## STAR ONLINE PUBLICATION

**Case Number:** S2523000016

**Symptom/Vehicle Issue:** Replacement Exterior Mirror Glass Connector Does Not Match For Blind Spot.

Fig 1.  
Early Mirror Glass Design  
Requires Adapter Jumper Harness When Installing New Design Mirror Glass.

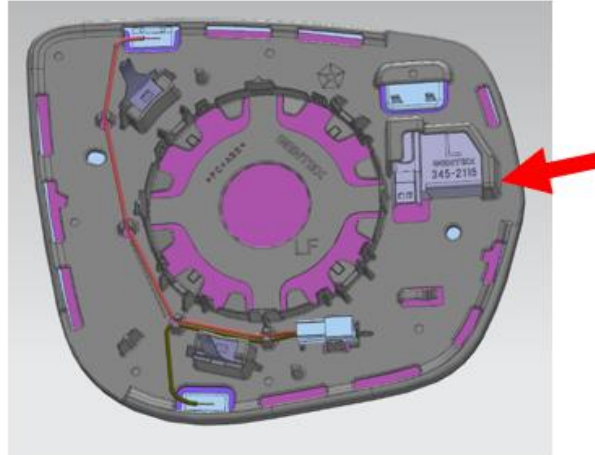
**Discussion:** During 2024 production there was an engineering change on exterior mirrors. The glass blind spot indicator changed. The “early mirror glass” design with the early blind spot is no longer available in MOPAR, however there is a “new mirror glass” design with the new blind spot monitor indicator for all the model years for production and service. This “new mirror glass” has a different connector for the blind spot indicator. An adapting jumper harness has been created to allow installation of the new mirror glass to the early mirror wiring with the new blind spot glass.

**Repair:** Remove the exterior mirror glass from the door mirror assembly. Compare the connections to the images below. Fig 1 shows an early design mirror that will require the adapter jumper harness. Fig 2 shows the new mirror glass design that does not require an adapter jumper harness.

- If you have an old mirror and need replacement glass (Fig 1) – order a service glass + a jumper to allow a connection to the old mirror wiring. Jumper 68674587AA
- If you have a new mirror that needs replacement glass (Fig 2) – order a service glass only - no jumper needed.
